SUMMARY OF CONCERNS IN RELATION TO THE PROPOSED NORTHCONNEX TUNNEL

SECTION A: THE CONNECTIVITY OF NORTHCONNEX SOUTHERN VENTILATION FACILITY AT THE SOUTHERN INTERCHANGE, THE SOUTHBOUND TUNNEL IN PARTICULAR

MOTORWAY OPERATIONS COMPLEX - SOUTHERN VENTILATION FACILITY - SECTIONS
M1-M2-5000-DR-JD-0525

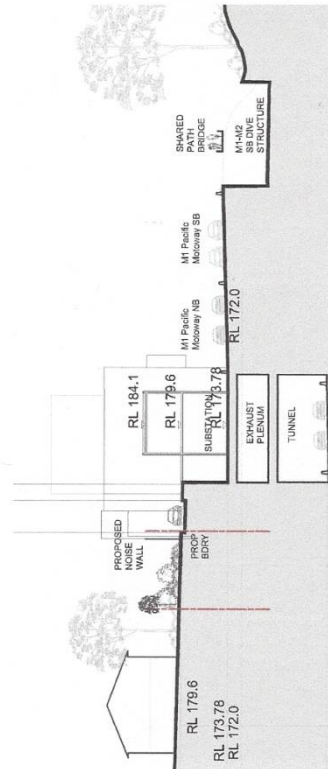
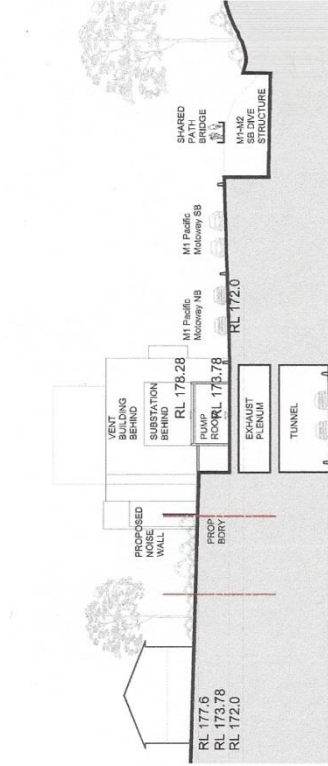
5. *EIS Volume 4, Technical working papers - Urban Design, 6.0 Operational Ancillary Facilities*
EIS Page 99 there is the diagram "Motorway Operations Complex – Southern Ventilation Facility – sections. *Page 10 below* The diagram has the cryptic label "Connection to tunnel TBC". What does TBC stand for? To be considered? Why is tunnel singular? Which tunnel is the diagram referring to northbound or southbound? There is no diagram showing any connection from the Southern Interchange ventilation facility to either the northbound or the southbound tunnel in any way
AND YET

- Diagrams need to be provided showing the inter-relation between the shaft, the ventilation outlet and the motorway operations centre with a clear description of what is to be constructed and how it will operate.
- The community needs irrefutable evidence that the polluted air from the southbound tunnel exit portals will not be allowed to flow like an invisible sewer through West Pennant Hills, North Rocks, Carlingford and Beecroft.

M1-M2-5000-DR-UD-0556
NORTHERN VENTILATION FACILITY - LONG SECTION

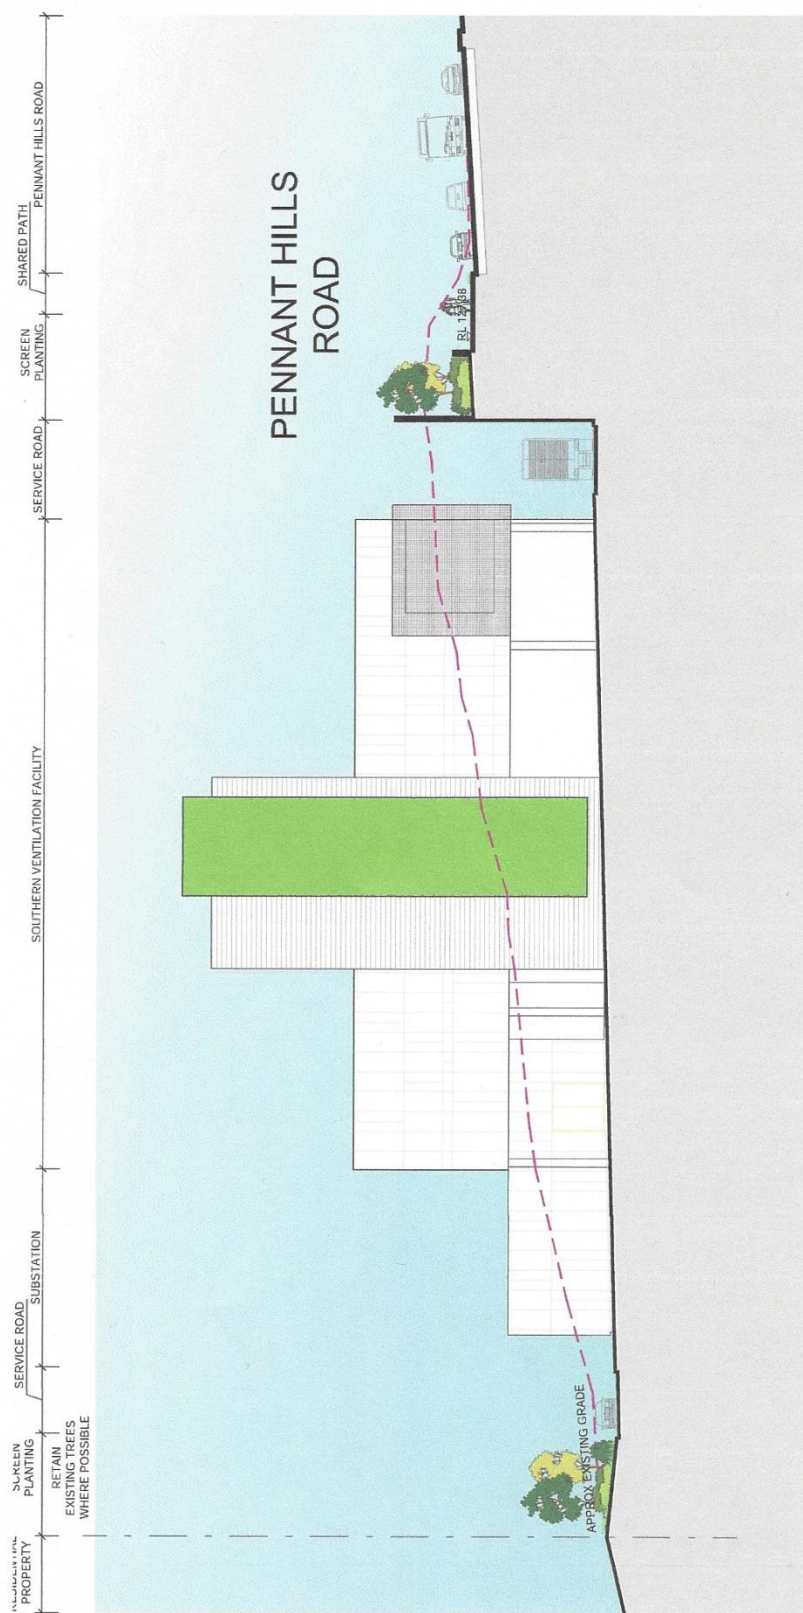
EIS page 135 *Page 11 below* there is a very explicit diagram showing the *Northern Ventilation Facility – cross section*.

EIS page 134 *Page 12 below* there is a very explicit diagram showing the *Northern Ventilation Facility – long section*.

Why are there no comparable diagrams for the Southern Interchange and the Southern Ventilation facility?

M1-M2-5000-DR-UD-0713
MOTORWAY OPERATIONS COMPLEX - SOUTHERN VENTILATION FACILITY - SITE SECTION 1-1

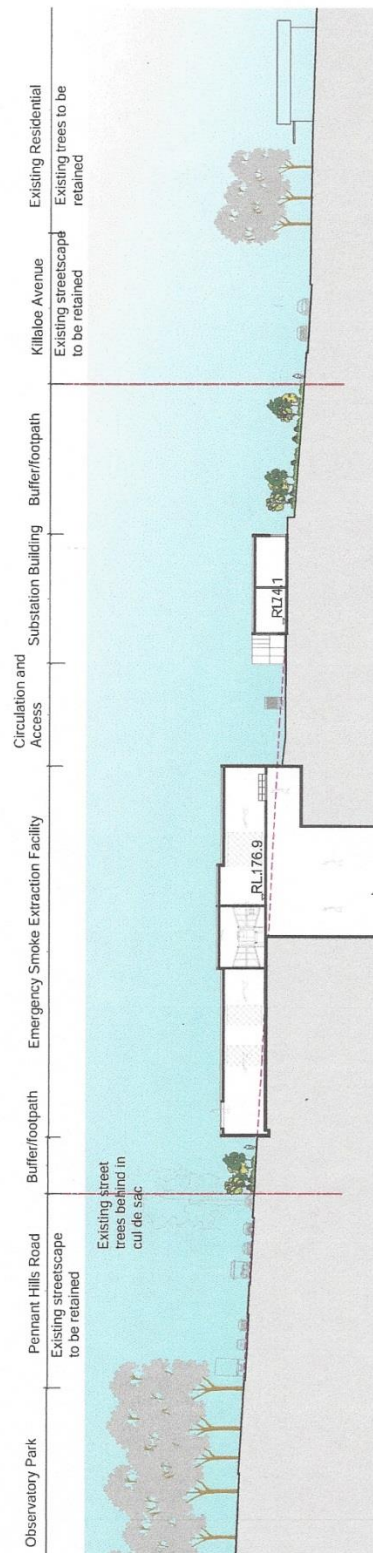
6. *EIS Volume 4, Technical working papers Urban Design, 8.0 Landscape Design*
EIS Page 176 is the diagram "Motorway Operations Complex – Southern Ventilation Facility – Site 1-1". *Page 13 below* The diagram does not show any connection to either the northbound or southbound tunnel. In the same Landscape Design section, EIS Page 182 is the diagram "Wilson Road Tunnel Support Facility –Section" *Page 14 below* which clearly shows the connection to the tunnels. In the same Landscape Design section, EIS Page 189 is the diagram "Northern Ventilation Facility – Landscape Concept Section". *Page 15 below* This also clearly shows the connection to the tunnels.
